**Addendum No. 1**  
 City of Coquitlam  
**RFP No. 25-014**

**Austin Works Yard Fleet Building Repurpose**  
 Issue Date: May 1, 2025  
 Total Page Count: 43 (including attachments)

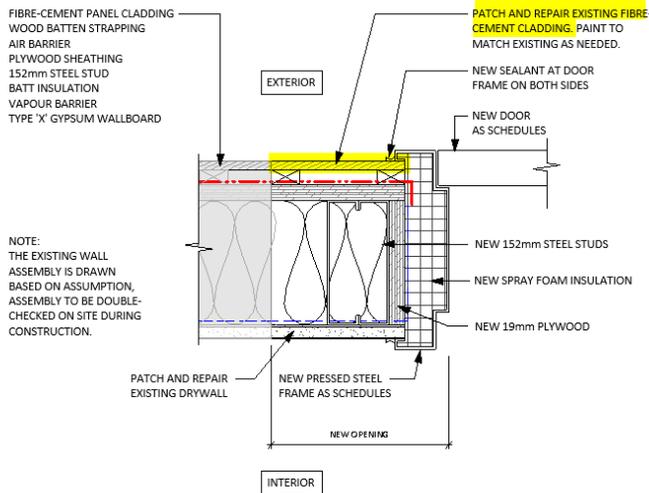
Q26. The HazMat report is quite extensive and there appears to be some abatement required – however as this is a renovation/upgrade our abatement contractors will need to do a thorough site tour to assess which elements (if any) will need abatement before removal/demolition/disposal. EG:- each of the door frames to be replaced will need to be assessed to see how it can be removed ie:- can it simply be cut out and disposed of or will a HazMat crew be required to remove and dispose of the frame because of lead paint, asbestos caulking etc. This is similar for all items of removal/disposal – everything from HVAC ducting, to drywall demolition, to overhead doors etc. Could we suggest a Cash Allowance be assigned to this item please for all bidders to carry in their Lump Sum Bid Price? We would suggest \$50,000.00g?

**A26. Contractors attended the mandatory site visit to assess the Scope of Work in conjunction with the RFP documents. It is the City's expectation that Contractors are able to provide a firm price to complete the Work as described. Any assumptions, concerns, or qualifications must be clearly stated in the Proposal and will be considered as part of the evaluation process. The City is seeking a Contractor who demonstrates a clear understanding of the Work and reflects this in their Proposal.**
